EUROCOPTER  
DIRECTION TECHNIQUE SUPPORT  
13725 MARGNANE CEDEX FRANCE

# EMERGENCY **ALERT SERVICE BULLETIN**

**SUBJECT: TIME LIMITS - MAINTENANCE CHECKS**

Check for crack in the main rotor hub

Figure 1: Visual check of the rotor hub

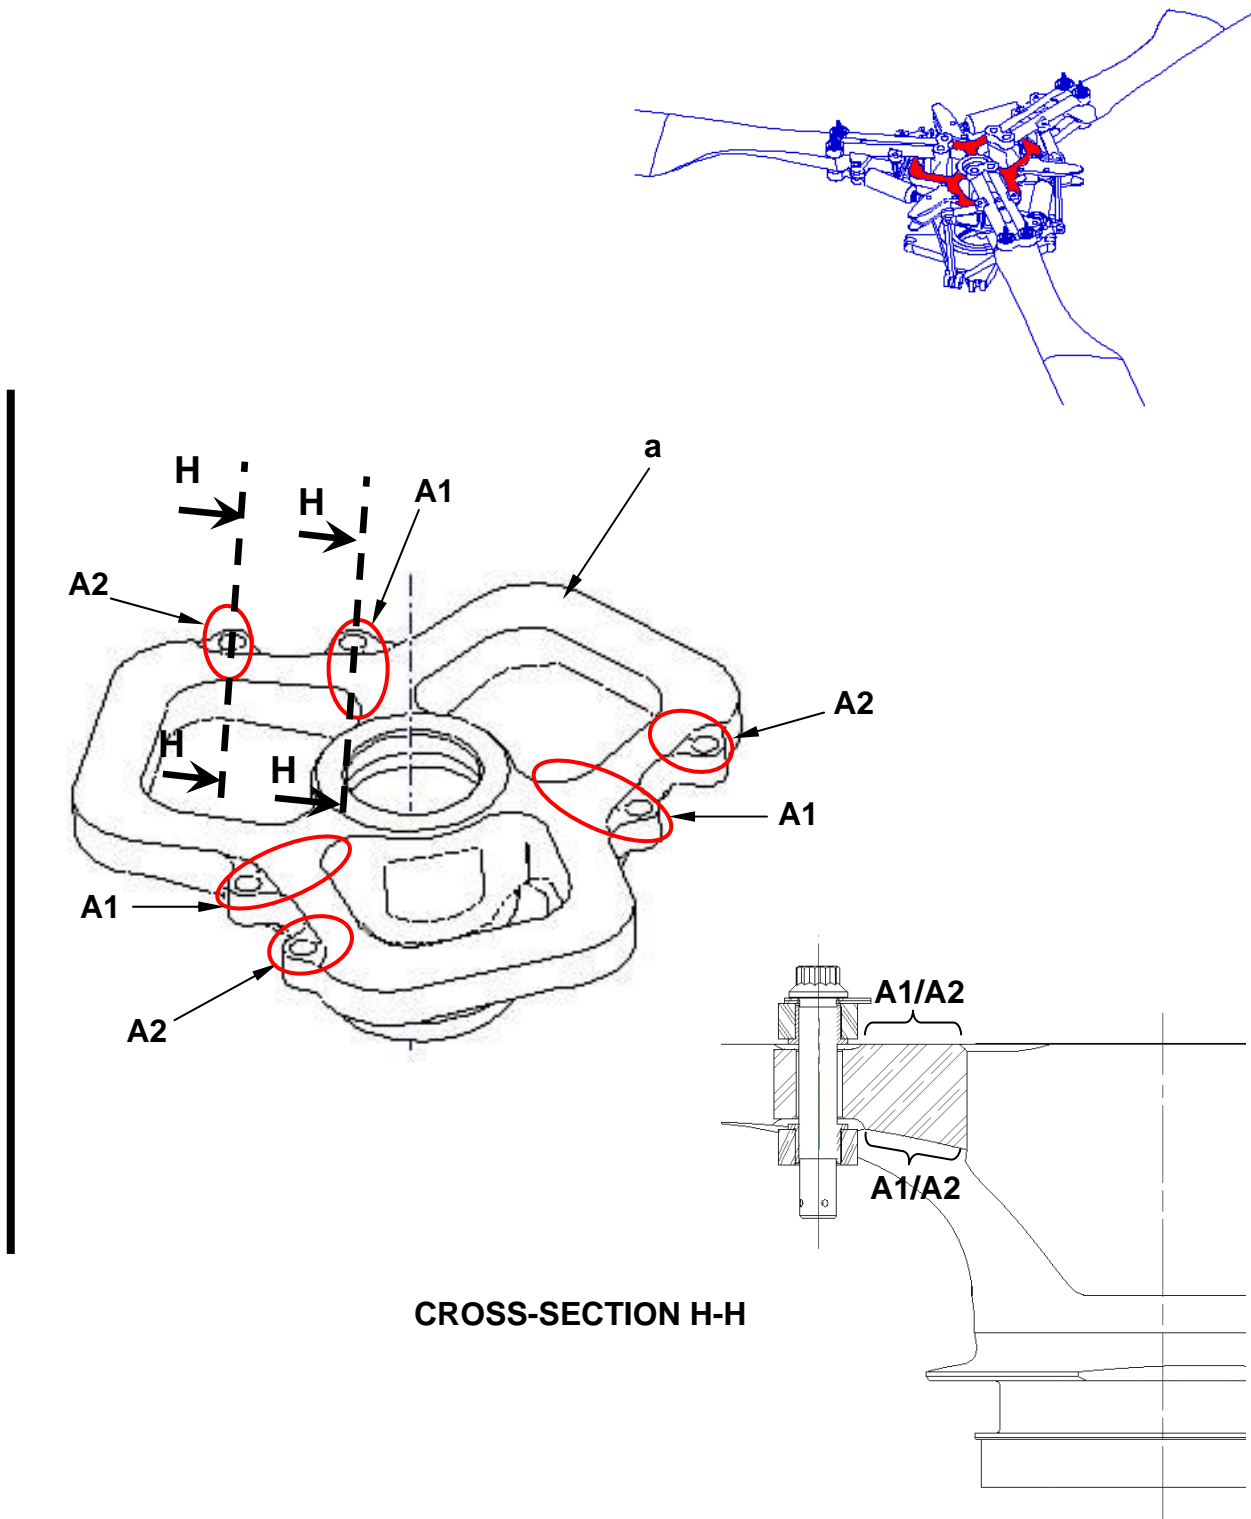
As per Figure 1:

- Visually inspect the inspection areas (A1) and (A2) on the hub (a), and make sure that there is no crack.
- Comply with paragraph 2.B.2.b.

- . Resume flights.
- 3 - If local deterioration is found, leading you to suppose that there could be a crack (scoring, paint spalling, etc.): (as per Figures 1 and 2):

- . Sand the suspected area(s) using No. 600-grit (fine grit) abrasive paper. Remove only the finish paint until the P05 primer coat becomes visible.

- . Once again, visually inspect the concerned area(s), and make sure that there is no crack.
  - . Interpret the results in accordance with paragraph 2.B.2.b.1. or paragraph 2.B.2.b.2.

Figure 2: Rotor hub – Identification plate

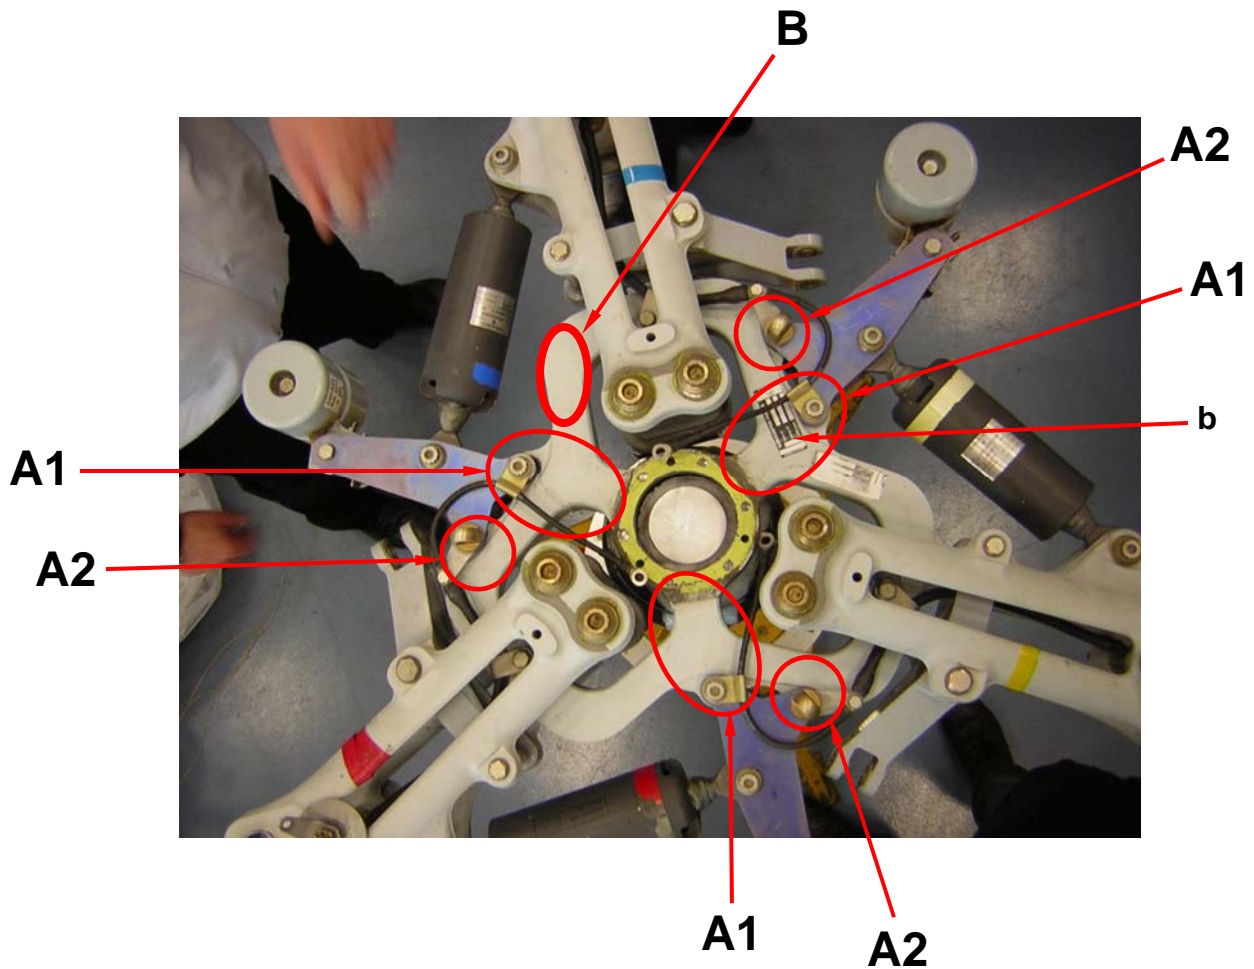
As per Figure 2:

- During the first check, if the identification plate (b) is in the inspection area (A1) or (A2), remove the plate (b):
  - . Unbond the identification plate (b) using a plastic tool or bronze knife, taking care not to damage the rotor hub. Remove the dome fairing if necessary.
  - . Locate the area (B), and then clean it as per Task 20-10-00, 3-8 (titanium part).
  - . Copy the references marked on the identification plate (b) on the area (B) with indelible ink, as per Task 20-10-00, 3-43.
